REGULATORY INFORMATION DISTRIBUTION SYSTEM (RIDS)

SUBJECT: Forwards addl mechanical info re containment purge & vent
 sys in response to NRC 800107 request. All purge sys
 isolation valves meet ASME Category I code requirements,
 including valves CV4309 & CV4310.

ADDITIONAL INFORMATION (MECHANICAL)
FOR
THE CONTAINMENT PURGE AND VENT SYSTEM
FOR
THE DUANE ARNOLD ENERGY CENTER
DOCKET 50-331

CONTAINMENT PURGE ISOLATION SYSTEM

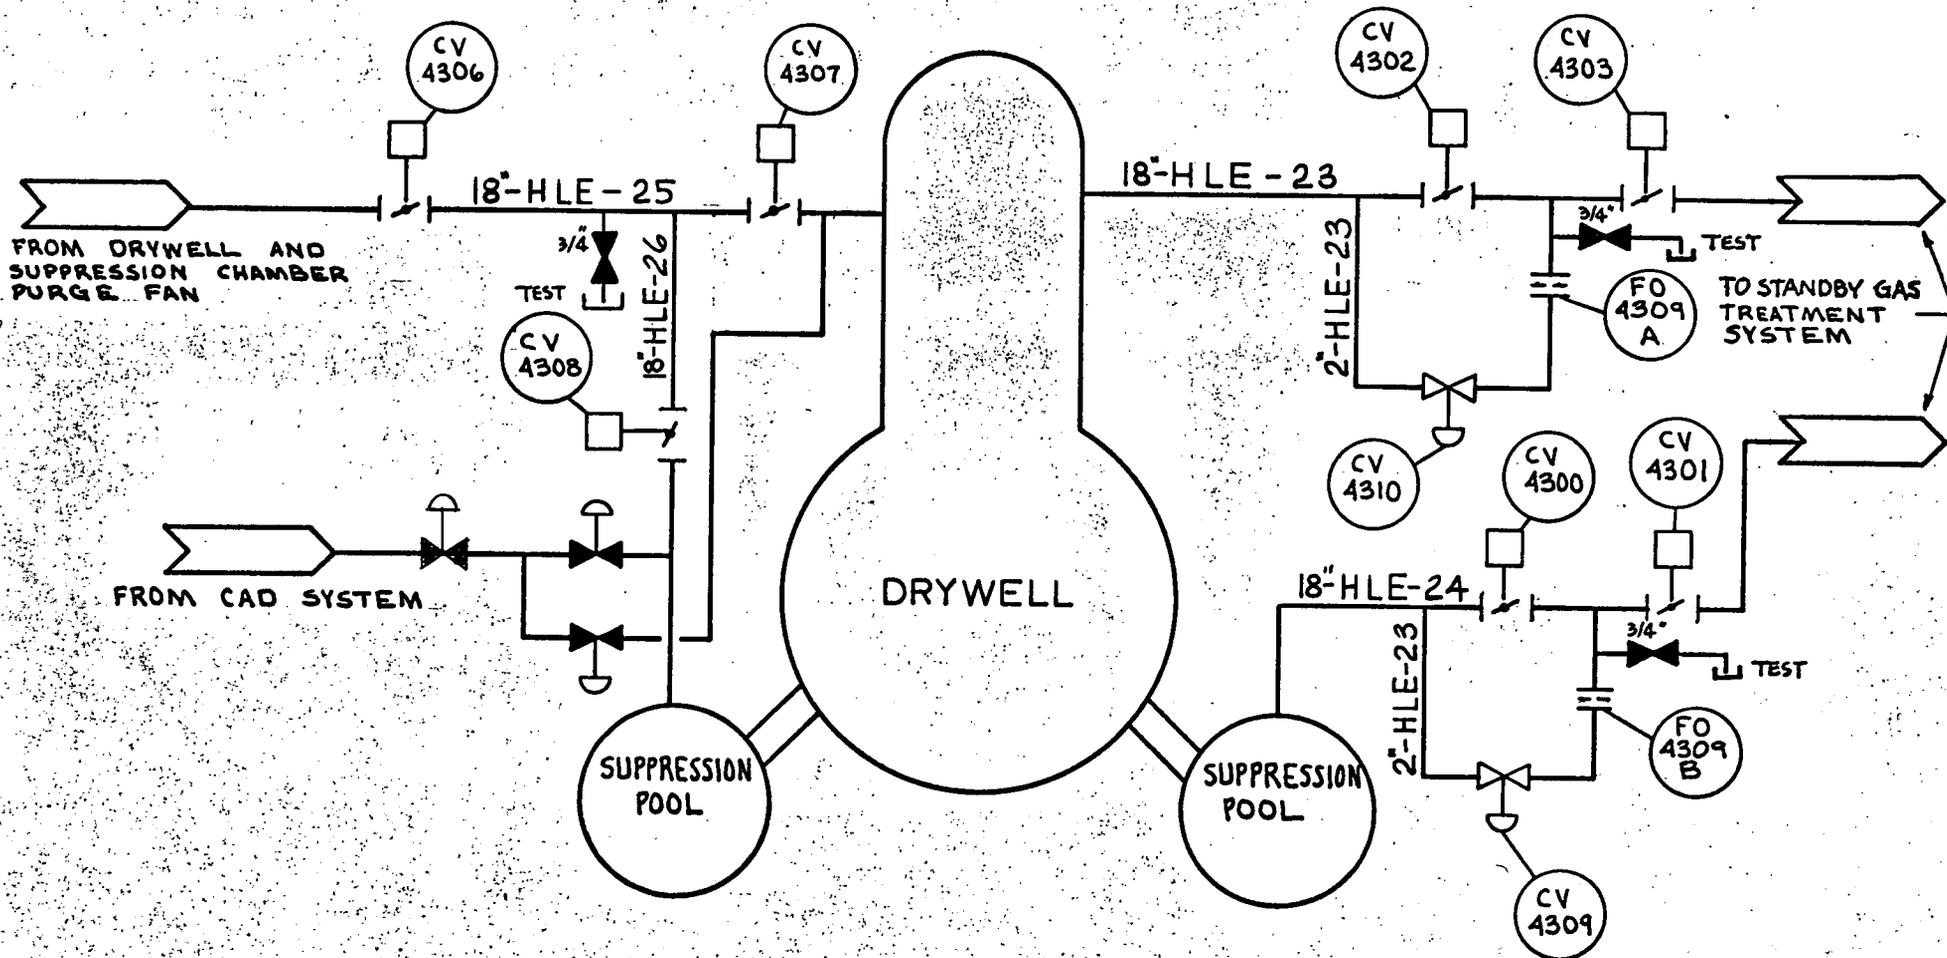
The primary containment purge system provides the means to introduce to and exhaust air from the drywell and pressure suppression chamber (refer to the attached sketch). A common fan supplies air to two ducts leading to each area. The exhaust from each area is routed to a common header which exhausts via the standby gas treatment system to the offgas stack.

The purge isolation valves can be individually tested for operability and isolation during reactor operation. The total leak rate for drywell/suppression pool purge, drywell vent, and suppression pool vent valve groups, as shown on the attached sketch, can be measured during reactor operation because they are all located outside the containment. The leak rate for each purge and vent line valve group represents the maximum leak rate that any single valve in that group might have.
